EDMS NO. 2905753	REV. 0.5	VALIDITY DRAFT
---------------------	-------------	-------------------

REFERENCE : LHC-LMQXFA-QN-0013

HL-LHC Nonconformity Report LQXFA/B01 Leak Check

Figure 1 – Pumping cart being backed by Adixen MSLD

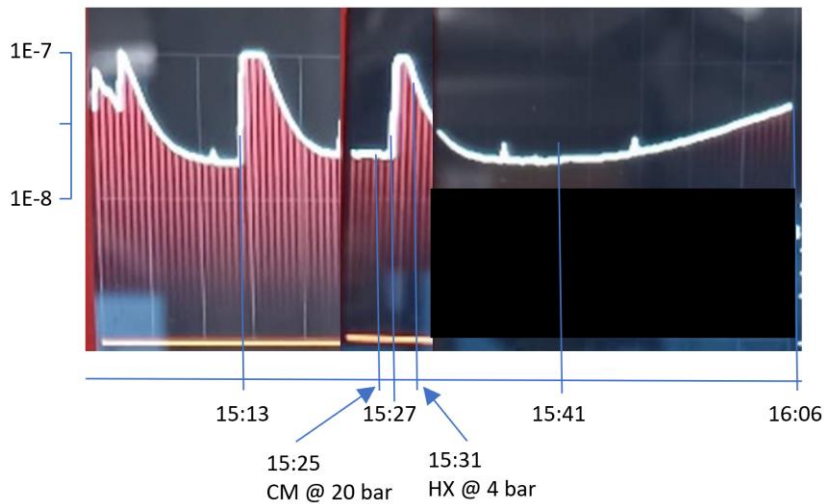
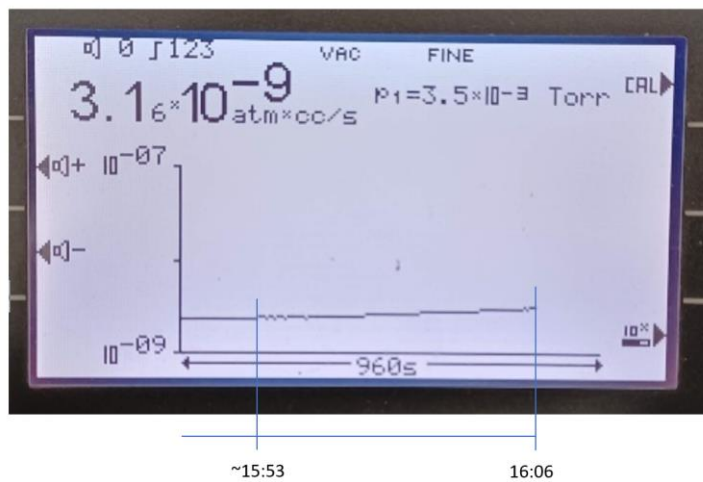
- A pumping cart (turbo, roots blower, roughing pump) was connected to one end of the cryoassembly, and an Adixen ASM390 leak detector was connected to back the turbo pump when valved in. The MSLD reached a stable background of $\sim 2.5E-8$ atm-cc/sec.

- At 15:41, 16 minutes after the CM reached full pressure (10 minutes after the HX reached full pressure), the MSLD backing the turbo started to show a slow rise in signal. This signal increase is attributed to Helium permeating through the O-rings used internally to the cryoassembly. A flexible hose assembly is used to complete the pressurization circuit between the cold mass and the non-IP end can. A metal seal was used at the connection between this flexible hose assembly and the Cold Mass. However, an elastomer seal was used at the connection between the flexible hose assembly and the end can.
